UNITED STATES
NUCLEAR REGULATORY COMMISSION
WASHINGTON, D. C. 20555

KEWAUNEE NUCLEAR POWER PLANT

Amendment No. 5
License No. DPR-43

ATTACHMENT TO LICENSE AMENDMENT NO. 5
CHANGE NO. 7 TO THE TECHNICAL SPECIFICATIONS
FACILITY OPERATING LICENSE NO. DPR-43
DOCKET NO. 50-305

FIGURE TS 6.2-1

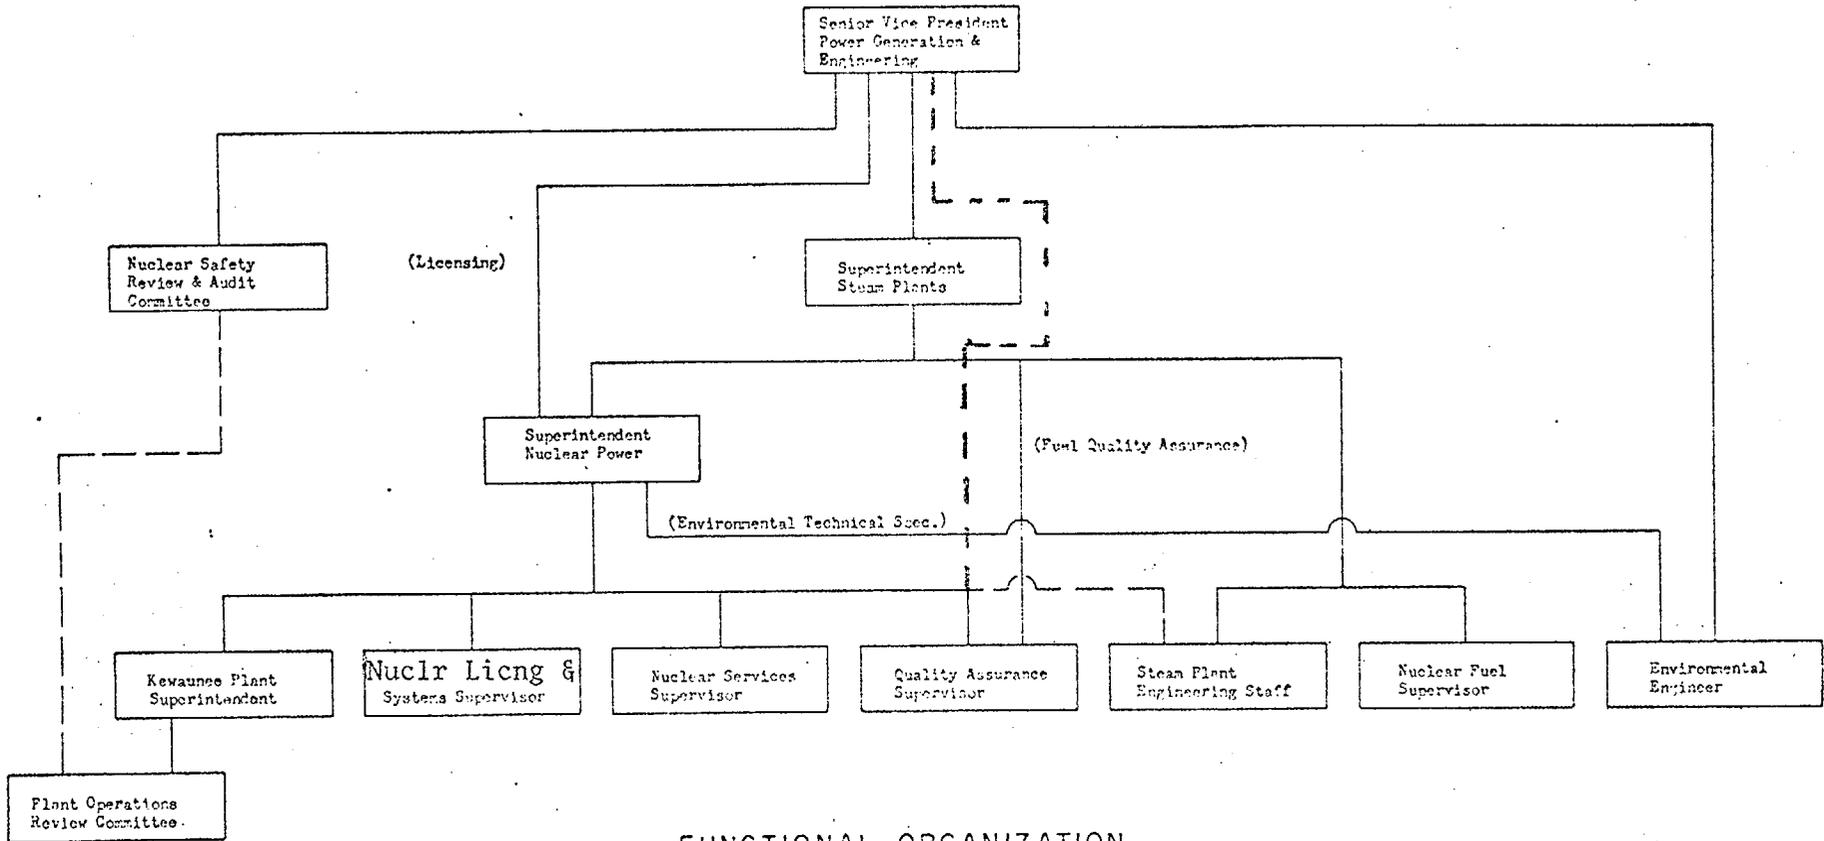
6.2.1 The offsite organization for plant management and technical support shall be as shown on Figure TS 6.2-1.

FIGURE TS 6.2-2

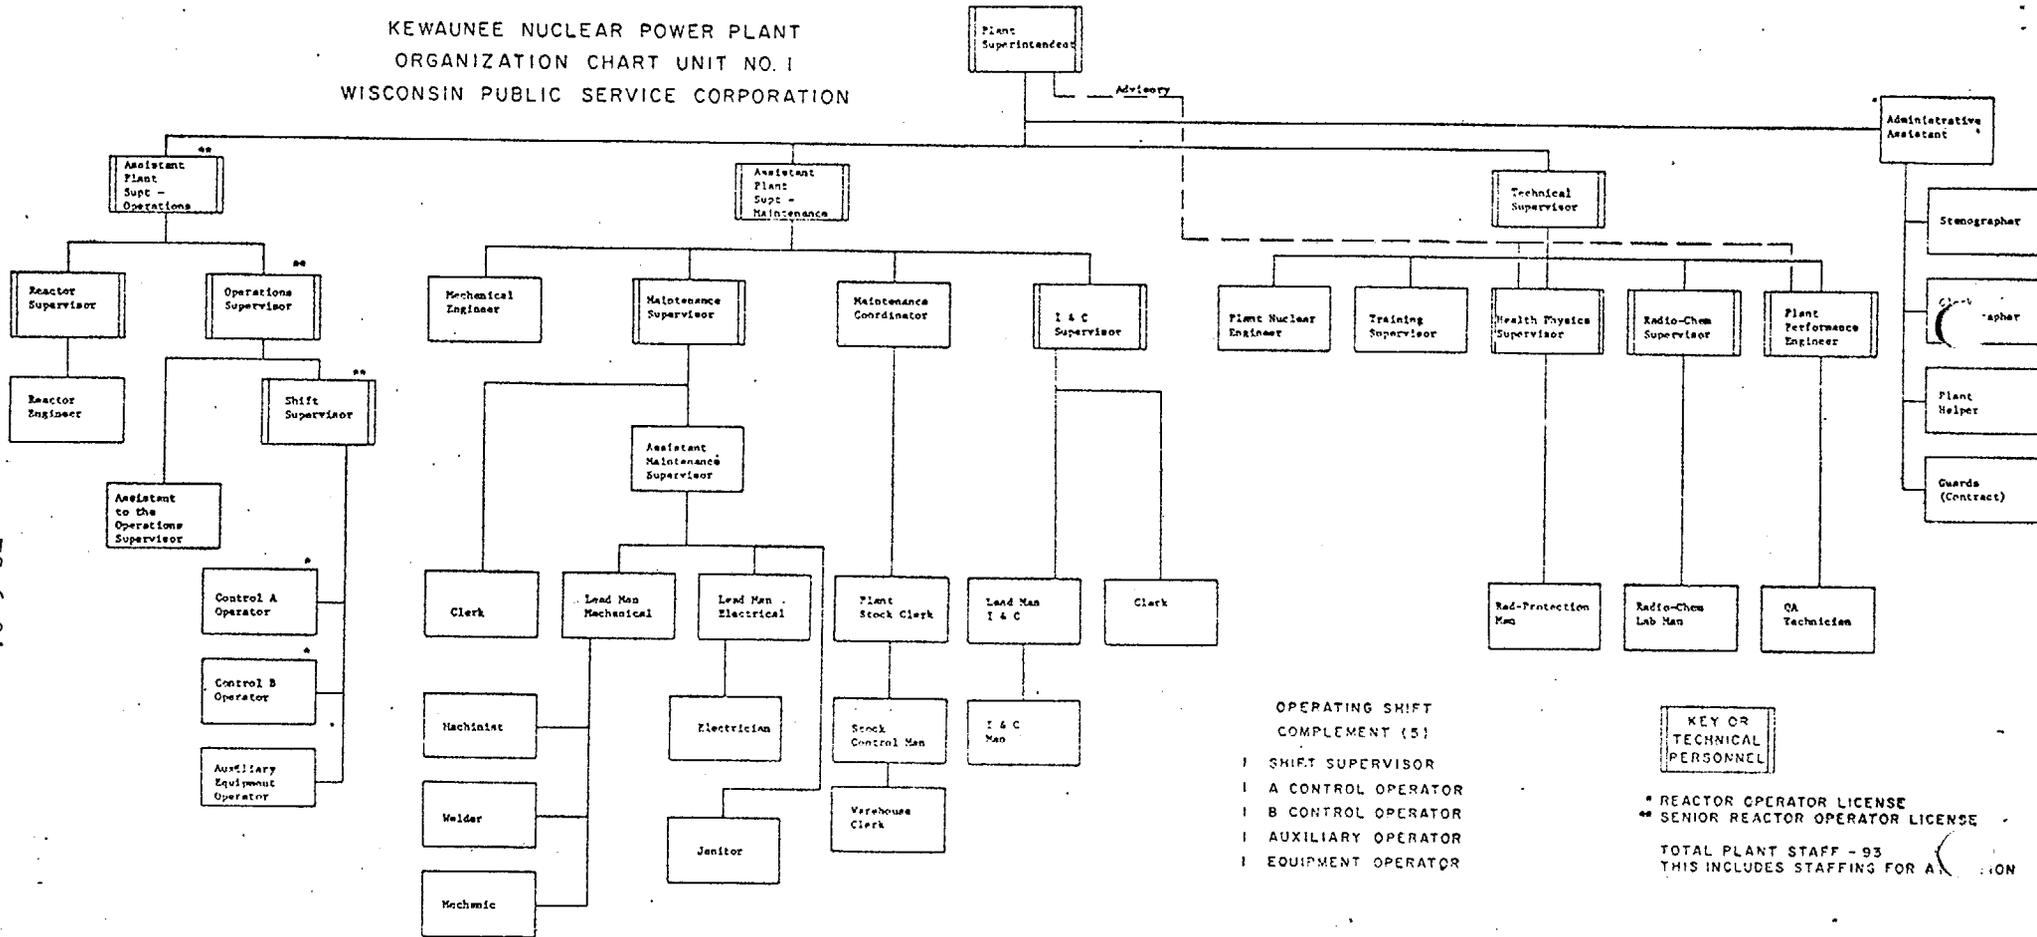
6.2.2 The plant organization shall be as shown on Figure TS 6.2-2 and:

- a. Each on-duty shift complement shall consist of at least:
 - (1) One Shift Supervisor (SRO)
 - (2) Two licensed Reactor Operators
 - (3) One Auxiliary Operator
 - (4) One Equipment Operator
- b. In the event that one of the shift members becomes incapacitated due to illness or injury, reactor operations may continue with the reduced complement until his replacement arrives. In all but severe weather conditions, a replacement is required within two hours.
